United States Patent and Trademark Office

APPLICATION NO.	FILING DATE	FIRST NAMED INVENTOR	ATTORNEY DOCKET NO.	CONFIRMATION NO.
10/809,341	03/26/2004	Atsuhisa Nakashima	119262 8238 EXAMINER	
25944 75	90 06/12/2006			
OLIFF & BERRIDGE, PLC			MRUK, GEOFFREY S	
P.O. BOX 19928 ALEXANDRIA, VA 22320			ART UNIT	PAPER NUMBER
			2853 DATE MAILED: 06/12/2006

DETAILED ACTION

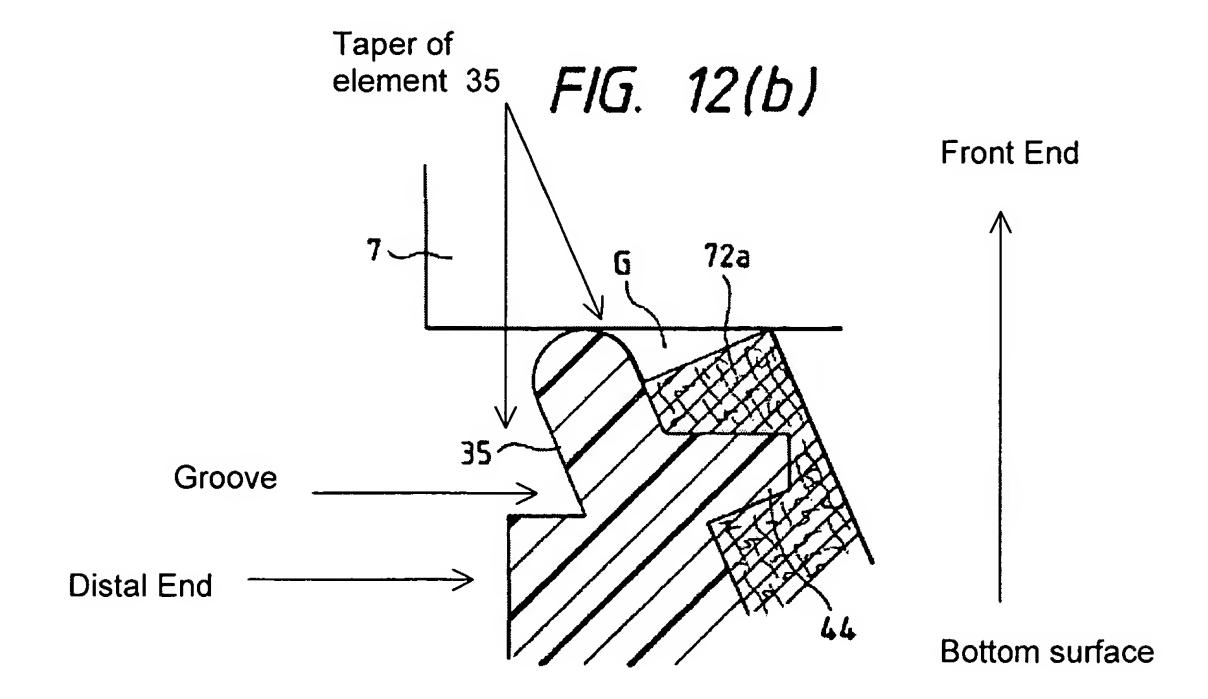
With respect to claim 4, Takahashi discloses each of the side lips (Fig. 7a, element 35b) has a front end and is formed into a tapered sectional shape which is smaller in width as a location goes from the bottom surface toward the front end (See Fig. 12b below); and the corner lip has substantially the same height (Column 6, lines 45-48, i.e. sealing the recording head) as the side lips and is smaller than the side lips in thickness (Column 6, lines 11-19; Claim 12).

With respect to claim 6, Takahashi discloses the ring-like lip includes a distal end (See Fig. 12b below) and a groove (See Fig. 12b below) that urges the distal end to be deformed in an outer side of the ring-like lip (Fig. 12b, element 35).
